RESIDENTIAL BUILDING PERMIT APPLICATION
 HOWARD COUNTY DEPARTMENT OF INSPECTIONS, LICENSES, AND PERMITS
 2430 COURT HOUSE DRIVE, ELLICOTT CITY, MD 21043 - PHONE: (410) 313-2455 OPTION #4
www.howardcountymd.gov

Amendment, Permit # B23002716

I am requesting to amend Permit # B23002716 at 13881 Triadelphia Mill Rd, Dayton Maryland, 21036 to

Re: Request for waiver: 13881 Triadelphia Mill Rd, Dayton, MD
Building Permit #B23002716

LOCATION DIAGRAM

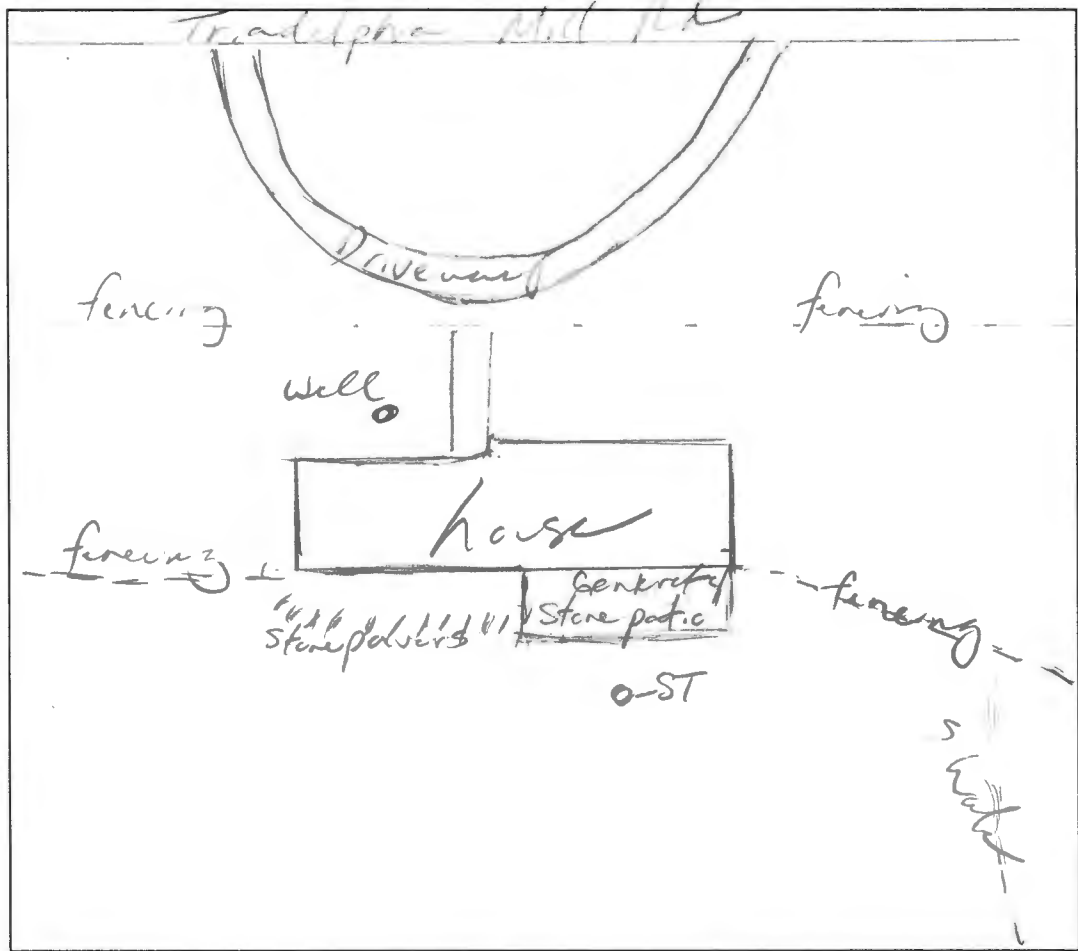
COMMENTS: Garage proposal near swale
and meets septic setback requirements. No
SDA on the property or evidence of hydraulic failure,
Repair in 1999 (11 90ft trench)

Site plan
1388 Triadelphia Mill Rd
3 car garage

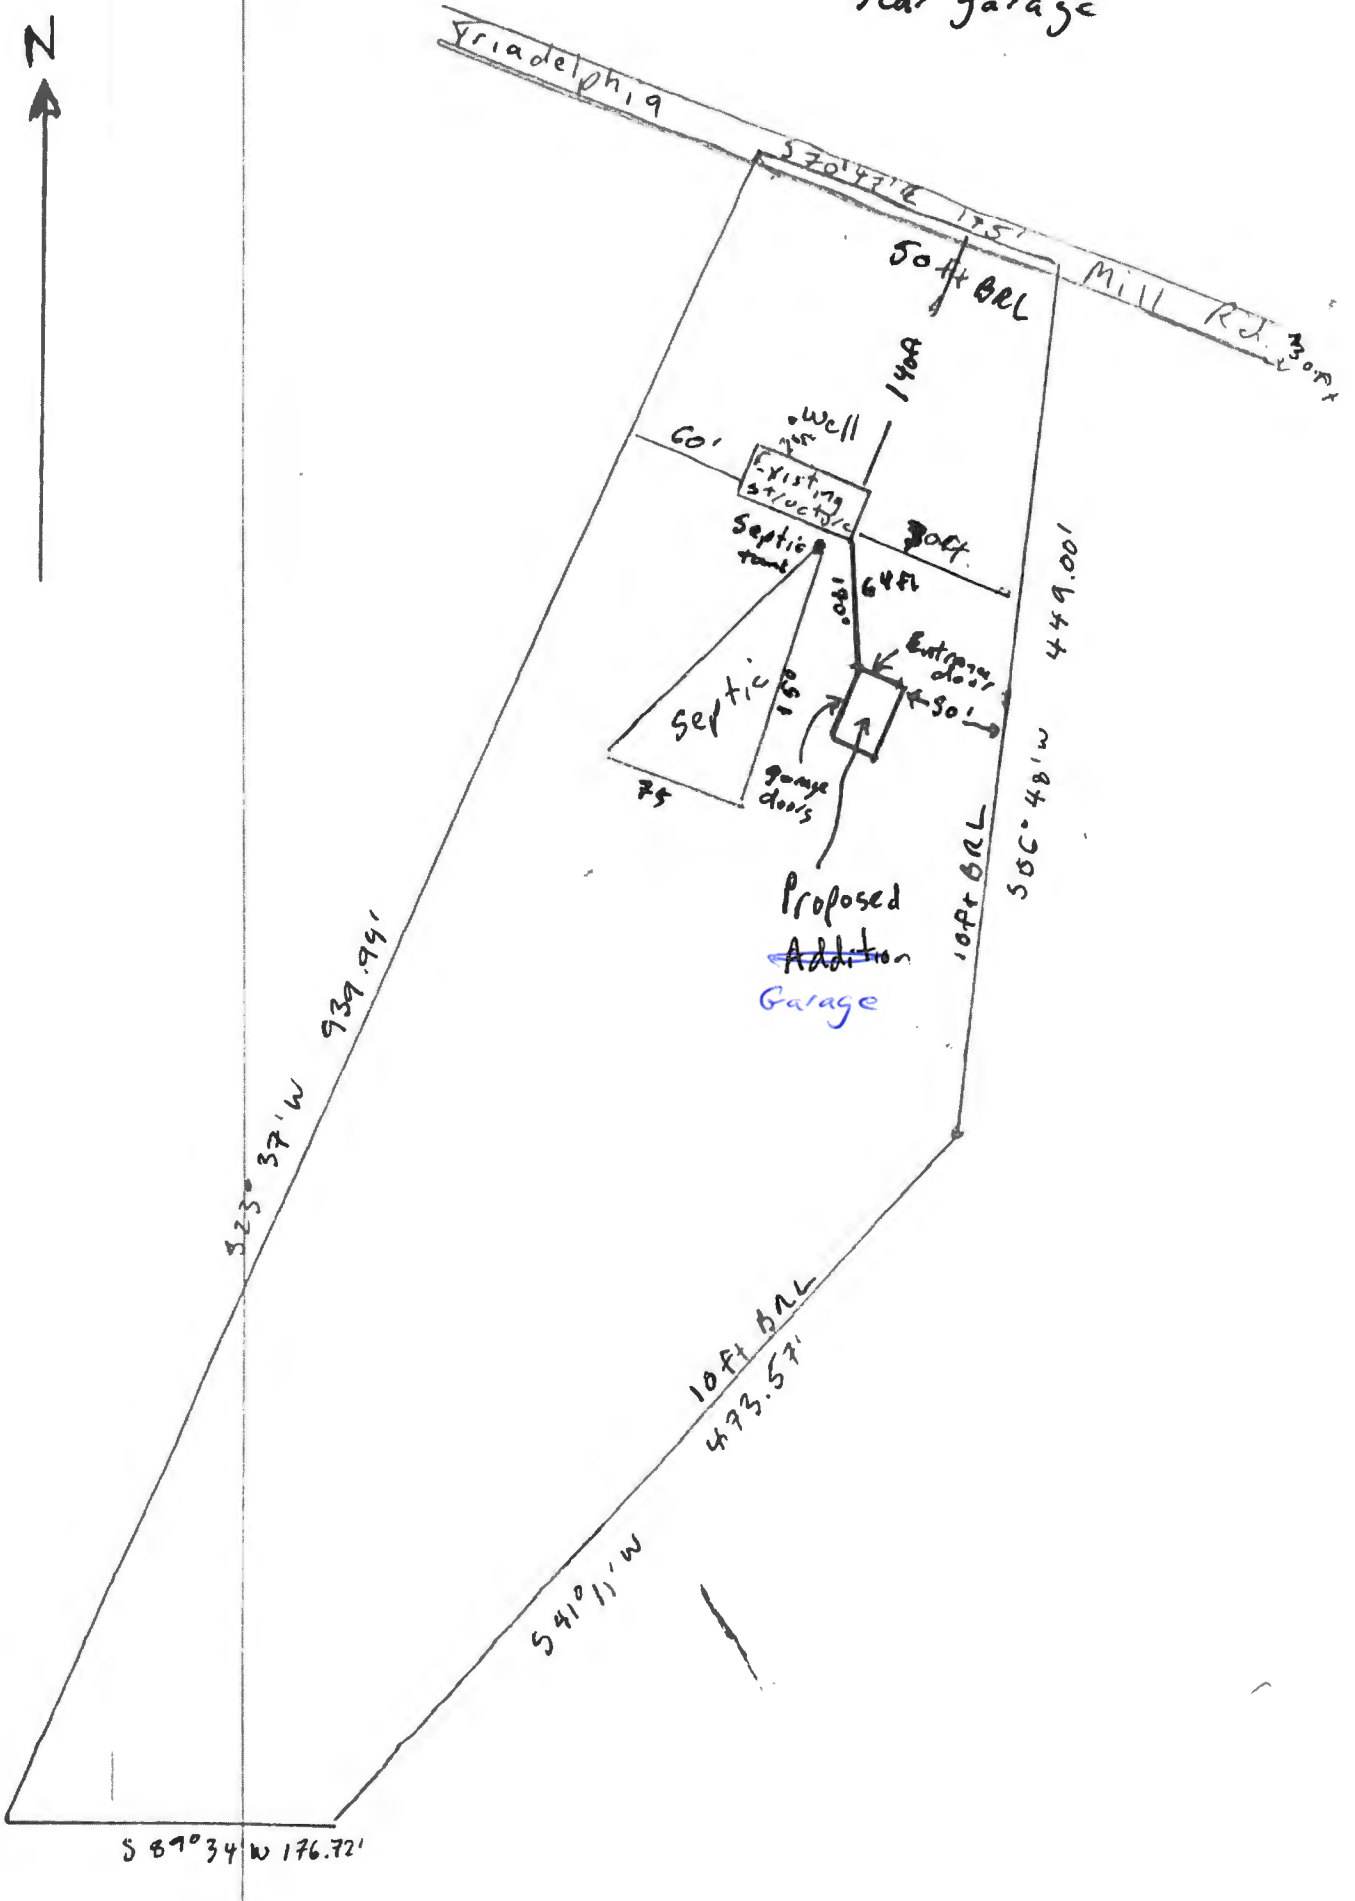
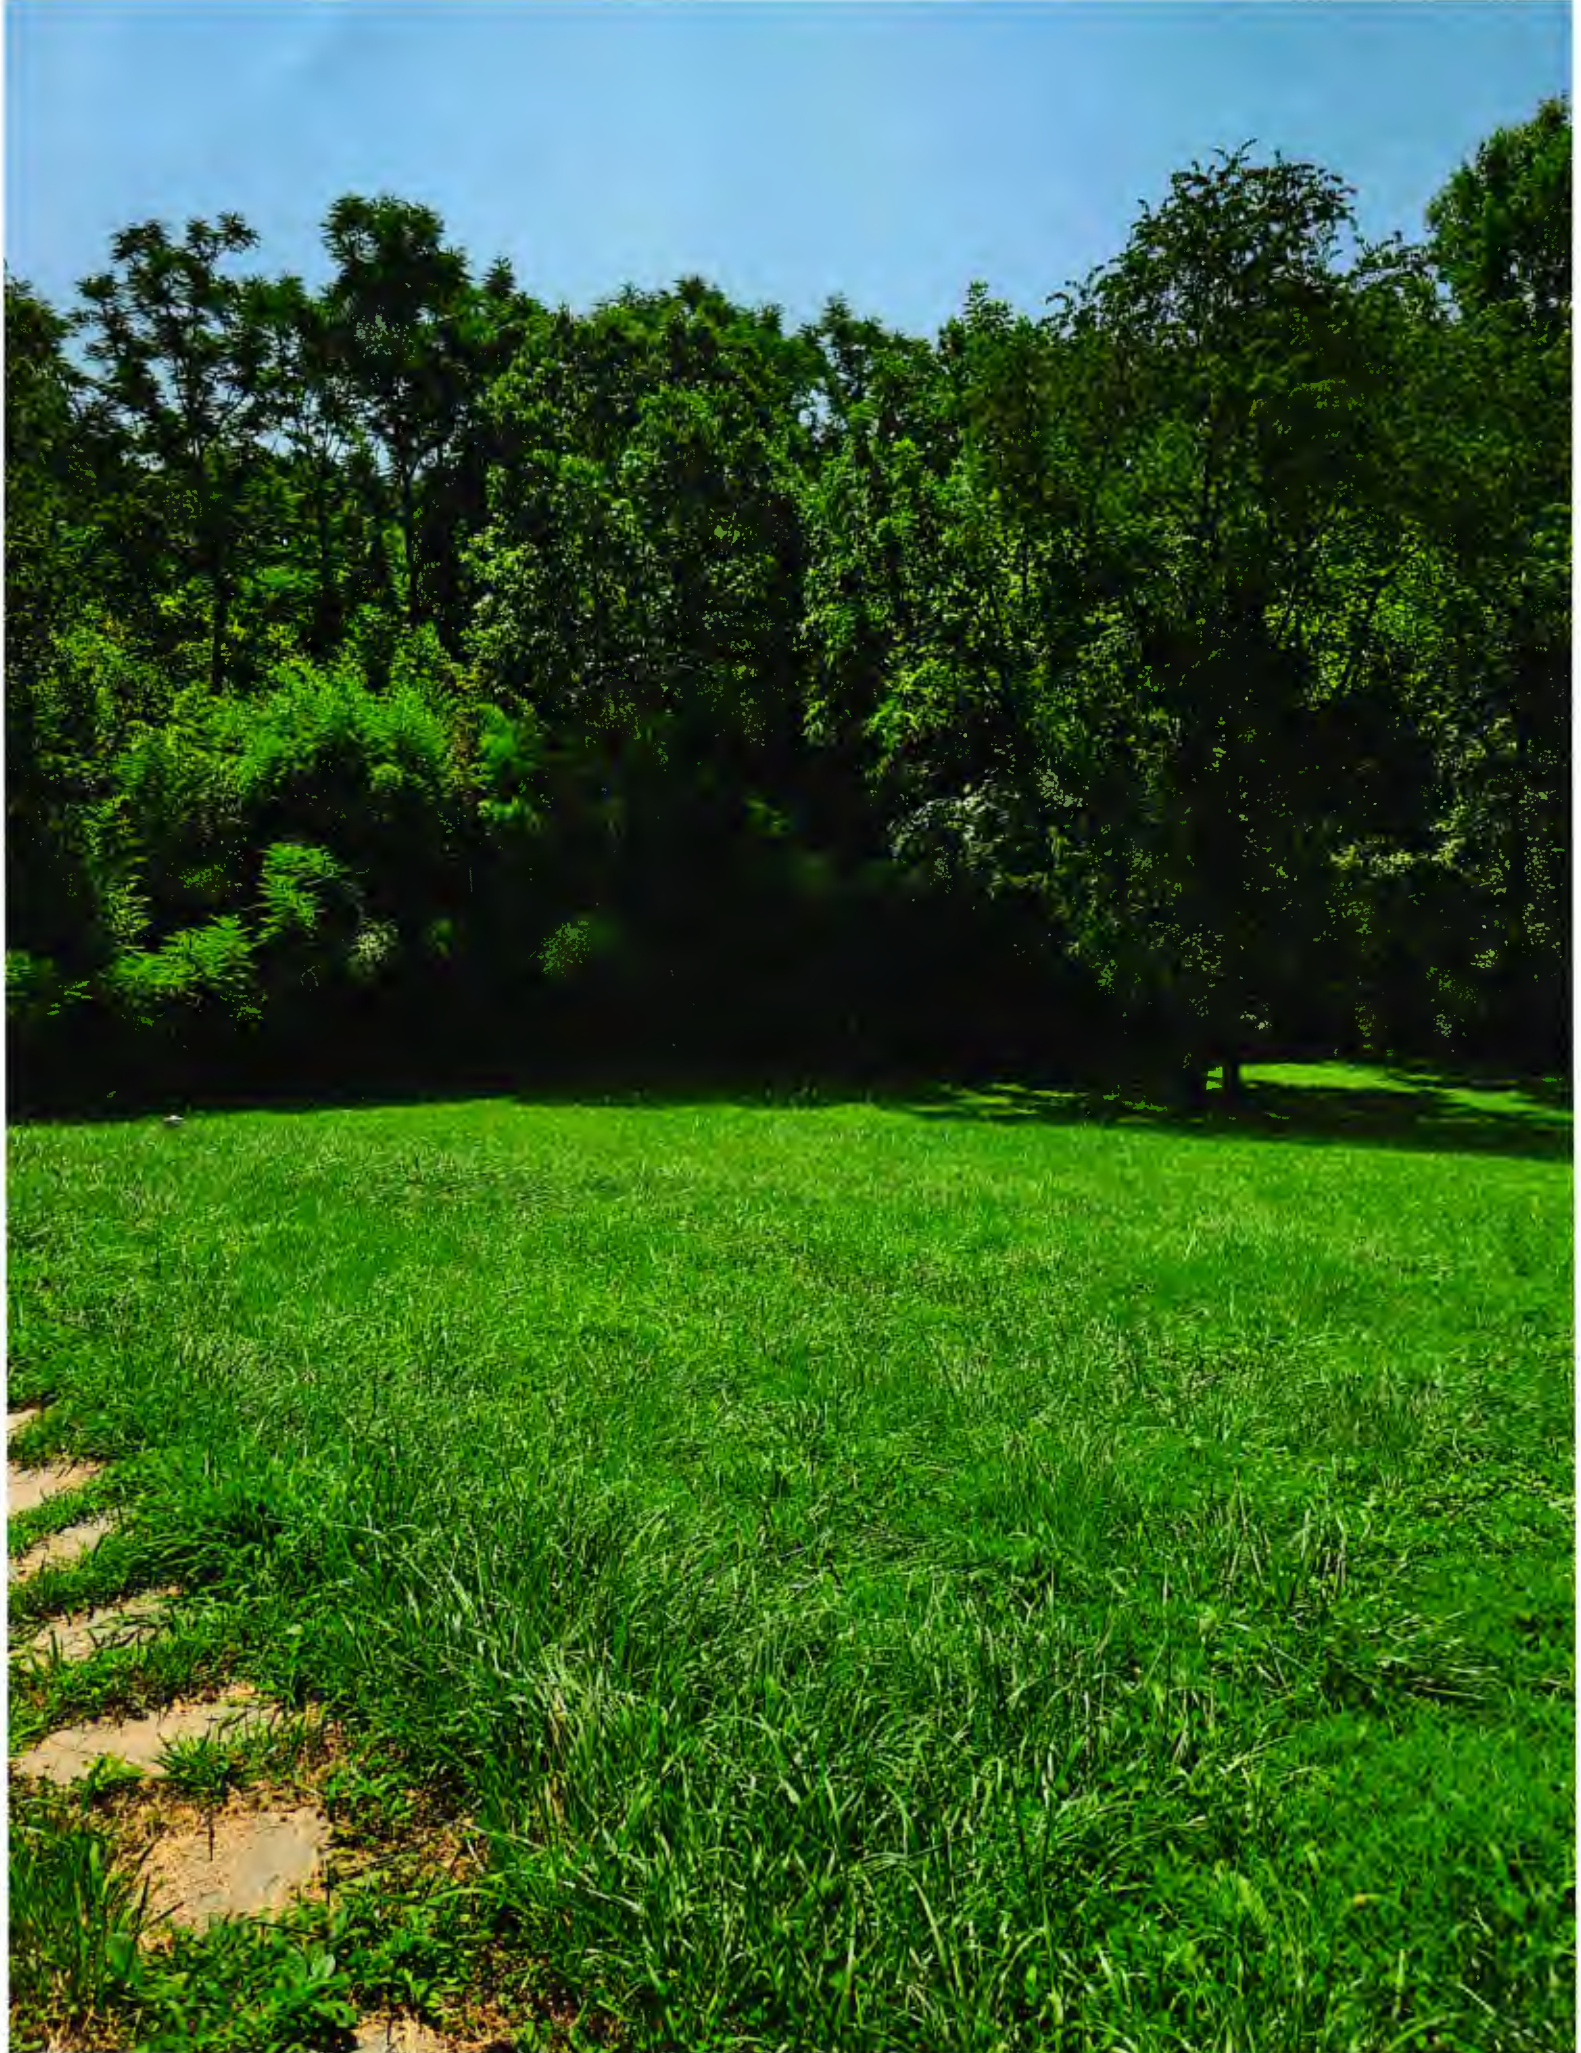
Change the location of the garage addition to a location more suitable for construction and use. The original site plan is included, as well as an updated site plan with detail. The new location is within the allowable area taking into account the 75 ft. offset from the front of the lot, and 30 feet from the adjacent property line.

Garage doors moved from 32 ft side (3) to 24 ft. side (2)
New drawings included, added 2 windows & Cupola

proposed location revised 12/4/23 - new
location in front yard inside 100' well
setback. ~~RE~~ Approved 12/4/23
